RFP 1126-25P

Addendum 002 Issued March 26, 2025

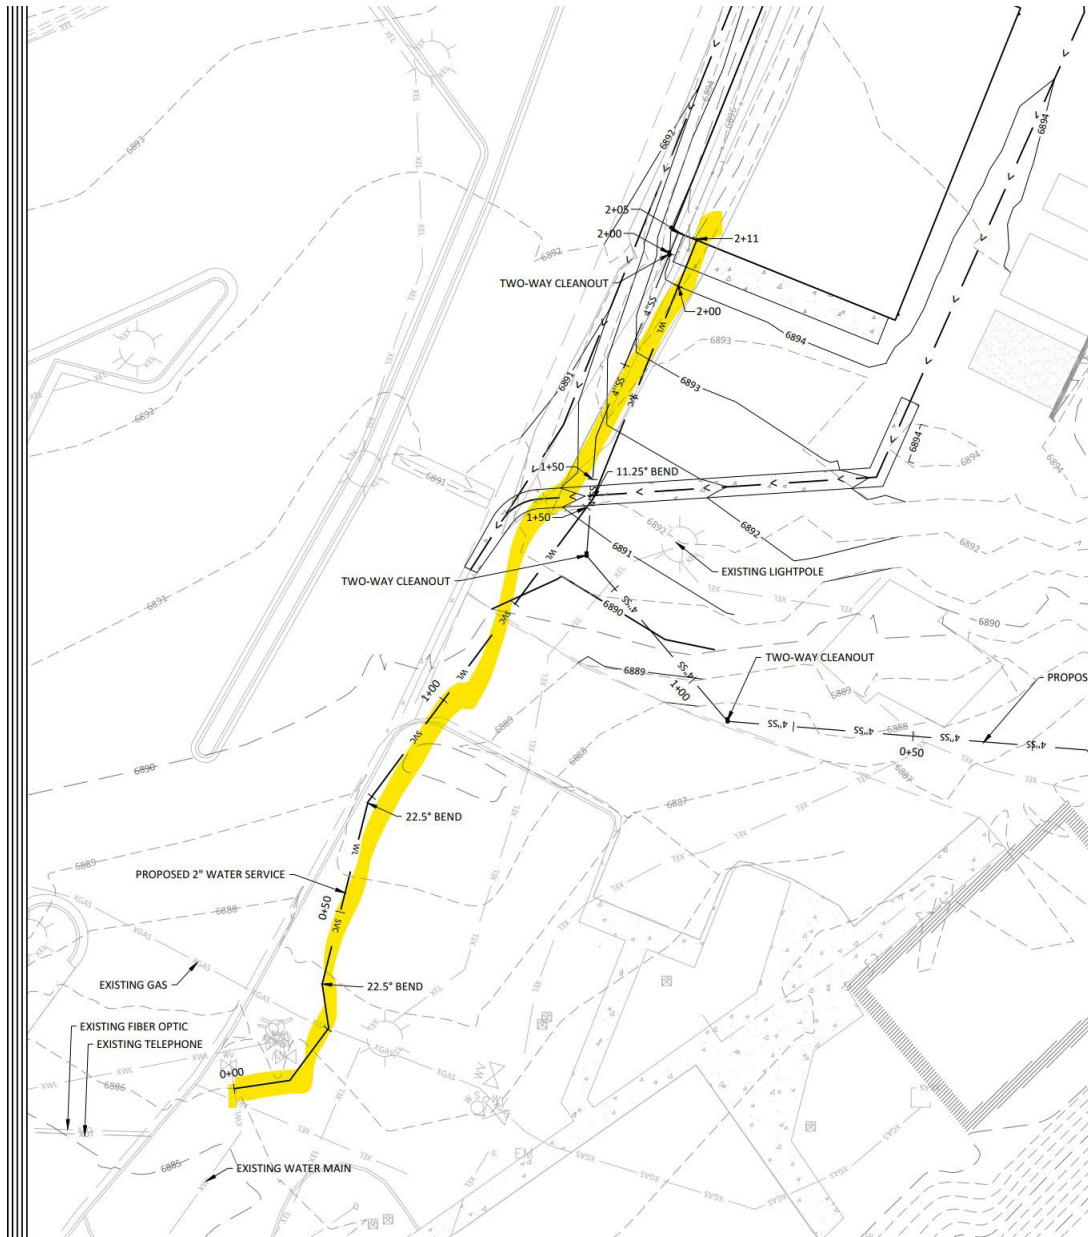
9. Where is the water coming from and is there a tap fee?

CIVIL: Currently the intent is that the water would tap near the existing hydrant; see screen shot below.
